**Intel 450KX/GX PCIset
Specification Update
82454KX/GX (PB)
82453KX/GX (MC)
82452KX/GX (DP)
82451KX/GX (MIC)**

Release Date: October 1997

Order Number: 243109-012

3. CMOS Overshoot/Undershoot Specification

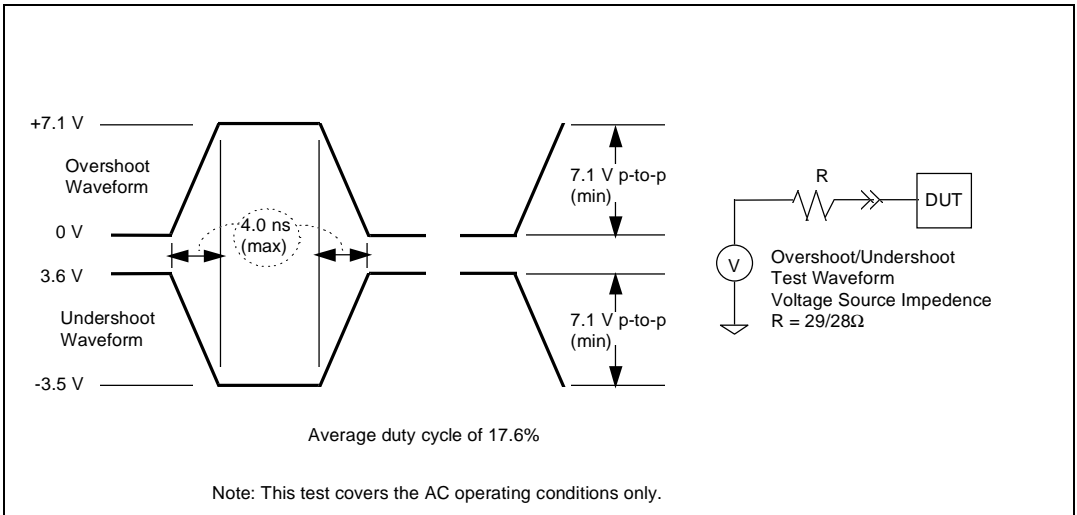
The following will be added to Chapter 4, Section 2.4, *Intel 450KX/GX Undershoot Specification*, in the *Intel 450KX/GX PCISSET* datasheet, and the section will be re-titled *Intel 450KX/GX Overshoot/Undershoot Specifications*.

The 3.3V tolerant CMOS signals of the processor bus allow for the following maximum AC waveforms:

6. ***Inbound Write Posting May Cause Write Failure***

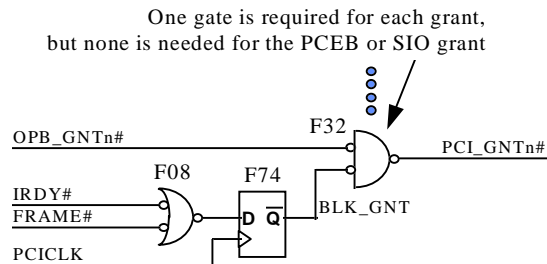
PROBLEM: During an inbound posted write burst, the 82454 PB may use the same data buffer for two adjacent transactions. This causes the first write to use and deallocate the data from the second write, corrupting data

and incorrectly deallocating a data buffer. When the data phase for the second write arrives, DBSY# may be asserted for some time, with no data phase or DRDY# assertion. When the PCI master completes the write burst, the deallocated buffer is never rewritten, resulting in a system hang with DBSY# asserted.

IMPLICATION: Enabling inbound write posting may cause data corruption followed by a system hang. Disabling inbound write posting may result in significant I/O performance loss.

WORKAROUND: An external arbiter should be implemented which allows inbound posting to be enabled, and guarantees at least two idle cycles between inbound PCI requests.

This arbiter must not perform overlapped arbitration. One way to ensure this is to implement the circuit described below, external to the arbiter. The actual workaround involves waiting for a bus idle before allowing a new grant to be issued. The IOQ depth must still be set to 1, and 2:1 interleaving must be used, to work around other errata which may surface when inbound write posting is enabled (even with this workaround). Note that this latter restriction requires at least 4 SIMM DRAM modules to be loaded at all times.

This following circuit is an implementation of the described workaround:

This workaround will allow inbound write posting to be enabled on A2 450KX PCIsset silicon, and will not affect the functionality of B0 450KX/GX PCIsset silicon, though a slight performance loss may result if this workaround is used with the B0 stepping. Enabling inbound posting by using this workaround is a significant performance enhancement for systems with A2 450KX PCIsset silicon; refer to Intel's World Wide Web site for more details on the performance loss incurred by disabling inbound write posting (at URL <http://www.intel.com/procs/support/ppro/82450.htm>).

Figure 1. V_{CC} Increase vs. T_{CASE} Drop for DPLL Failure (Worst Case)

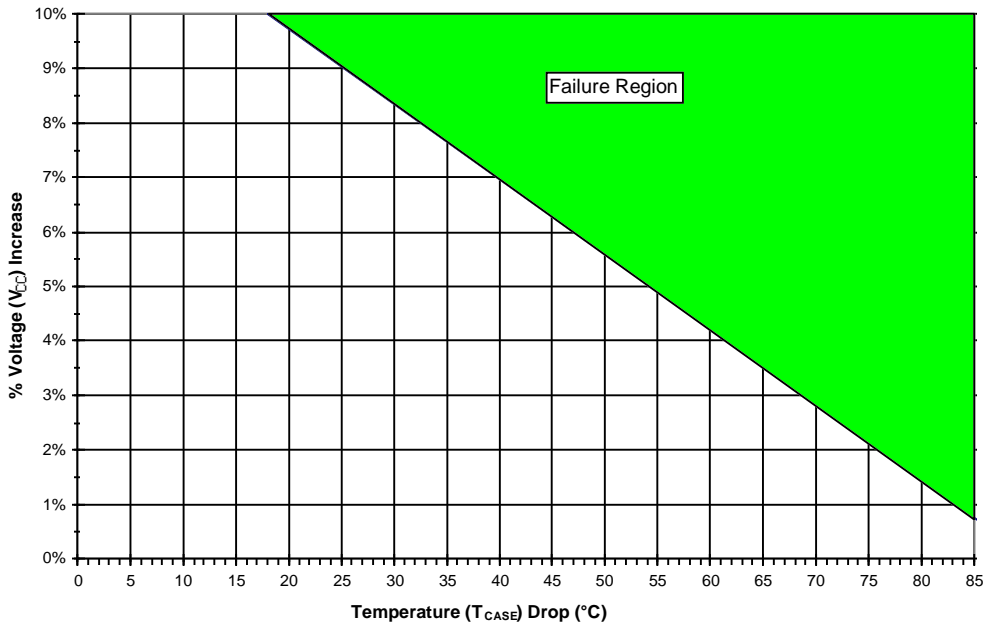
The current specification states that the Intel 450KX/ PCIsset is operational over a T_{CASE} range of 0 - 85°C and a V_{CC} range of 3.3V ± 5%.

After a device has undergone a hard reset of the DPLL (via the PLLRST pin), a drop in T_{CASE} accompanied by an increase in V_{CC} may cause this erratum to occur. The magnitude of the temperature drop and supply voltage increase required to cause this failure is graphed below:

IMPLICATION: If the T_{CASE} of any Intel 450KX PCIsset component is allowed to decrease by more than 18°C after the point at which DPLL lock is obtained after a DPLL hard reset, a positive voltage swing may cause the component to lose its internal clock for 2 - 500 processor bus clocks. This may result in a system hang, lost data, or other unpredictable system failure (note that if the component is not processing commands or data for the time during which the internal clock is lost, no failure will be observed). The larger the temperature drop and/or voltage swing, the more likely the failure.

3. CMOS Overshoot/Undershoot Specification

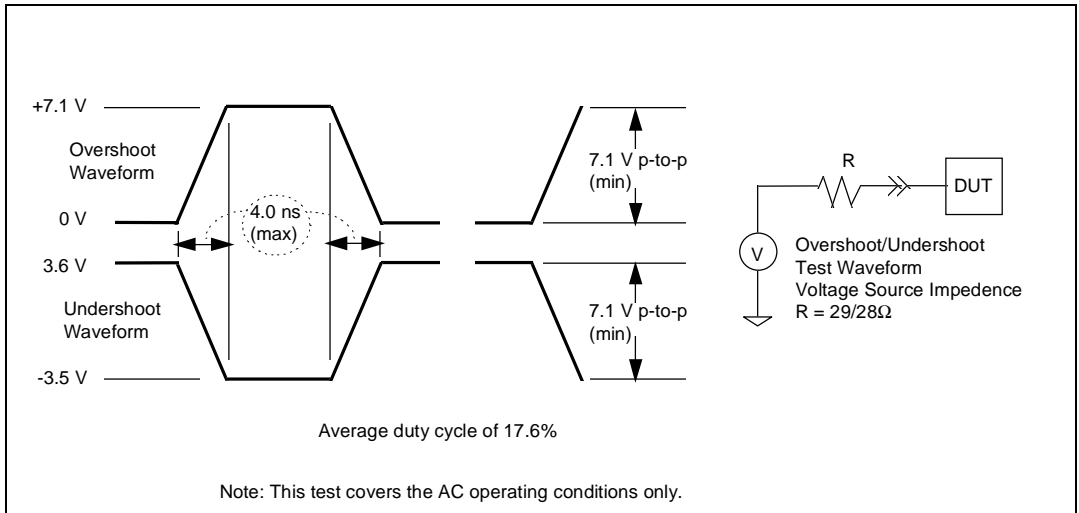
The following will be added to Chapter 4, Section 2.4, *Intel 450KX/GX Undershoot Specification*, in the *Intel 450KX/GX PCIsset* datasheet, and the section will be re-titled *Intel 450KX/GX Overshoot/Undershoot Specifications*.

The 3.3V tolerant CMOS signals of the processor bus allow for the following maximum AC waveforms:

Figure 1. V_{CC} Increase vs. T_{CASE} Drop for DPLL Failure (Worst Case)

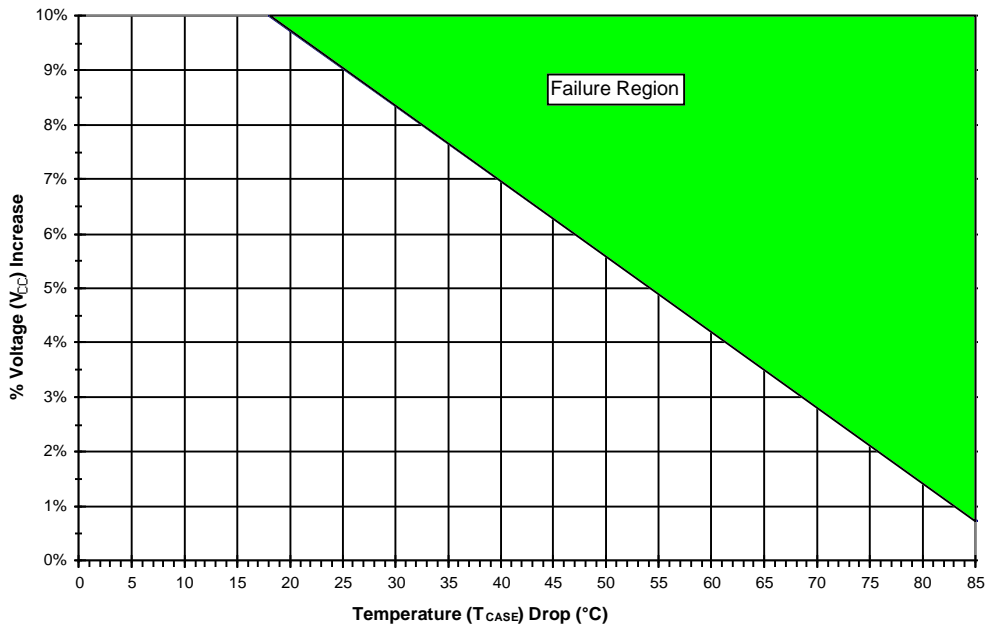
The current specification states that the Intel 450GX PCIsset is operational over a T_{CASE} range of 0 - 85°C and a V_{CC} range of 3.3V ± 5%.

After a device has undergone a hard reset of the DPLL (via the PLLRST pin), a drop in T_{CASE} accompanied by an increase in V_{CC} may cause this erratum to occur. The magnitude of the temperature drop and supply voltage increase required to cause this failure is graphed below:

IMPLICATION: If the T_{CASE} of any Intel 450GX PCIsset component is allowed to decrease by more than 18°C after the point at which DPLL lock is obtained after a DPLL hard reset, a positive voltage swing may cause the component to lose its internal clock for 2 - 500 processor bus clocks. This may result in a system hang, lost data, or other unpredictable system failure (note that if the component is not processing commands or data for the time during which the internal clock is lost, no failure will be observed). The larger the temperature drop and/or voltage swing, the more likely the failure.
